SUNDRY NOTICES AND REPORTS ON WELLS

1. Type of Well <input checked="" type="checkbox"/> Oil Well <input type="checkbox"/> Gas Well <input type="checkbox"/> Other		5. Lease Serial No. LC 057210
2. Name of Operator ConocoPhillips Company		6. If Indian, Allottee or Tribe Name
3a. Address 4001 Penbrook Street Odessa TX 79762	3b. Phone No. (include area code) (432)368-1667	7. If Unit or CA/Agreement, Name and/or No. MCA Unit
4. Location of Well (Footage, Sec., T., R., M., or Survey Description) 1295' FNL & 675' FWL UL "D", Sec. 28, T-17-S, R-32-E		8. Well Name and No. #394
		9. API Well No. 30-025-37931
		10. Field and Pool, or Exploratory Area Maljamar; Grayburg-San Andres
		11. County or Parish, State Lea NM

ALTERNATIVE CASING & CEMENTING PROGRAM PROPOSAL
MCA 394, MCA 395, MCA 396, MCA 397, & MCA 407

ALTERNATIVE CASING & CEMENTING PROGRAM PROPOSAL
MCA 394, MCA 395, MCA 396, MCA 397, & MCA 407

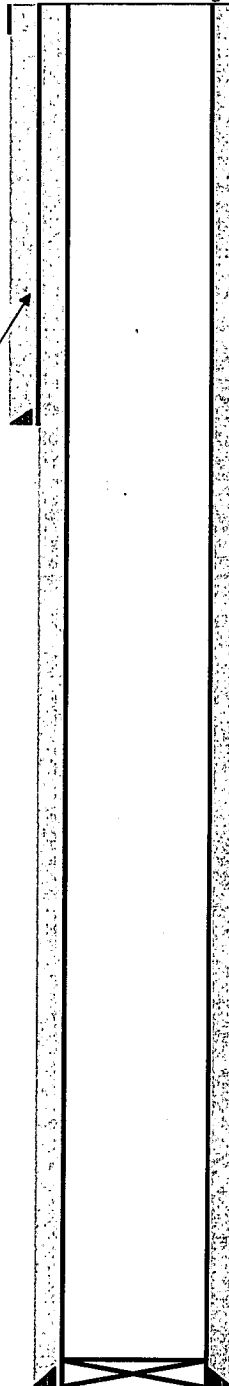
Variance requested / propoposed to allow us to test
 the Surface Casing to 1000 psi instead of to 1500
 psi.

Production casing cement volumes will be adjusted based on
 open hole caliper log data if available.

Lead Slurry: 750 sx
 50/50 POZ:Class C
 + 5% bwow D44 salt
 + 0.25 pps D29 celloflake
 + CemNet if needed
 Mix Weight = 13.6 ppg,
 Yield = 1.49 cuft/sx yield,
 Mix Water = 7.39 gal/sx
 Top of Lead Slurry at Surface

Tail Slurry: 480sx
 35:65 POZ:Class H
 + 0.4% D65 dispersant
 + CemNet if needed
 Mix Weight = 16.4 ppg,
 Yield = 0.98 cuft/sx yield,
 Mix Water = 3.71 gal/sx
 Top of Tail Slurry at 3000' MD RKB
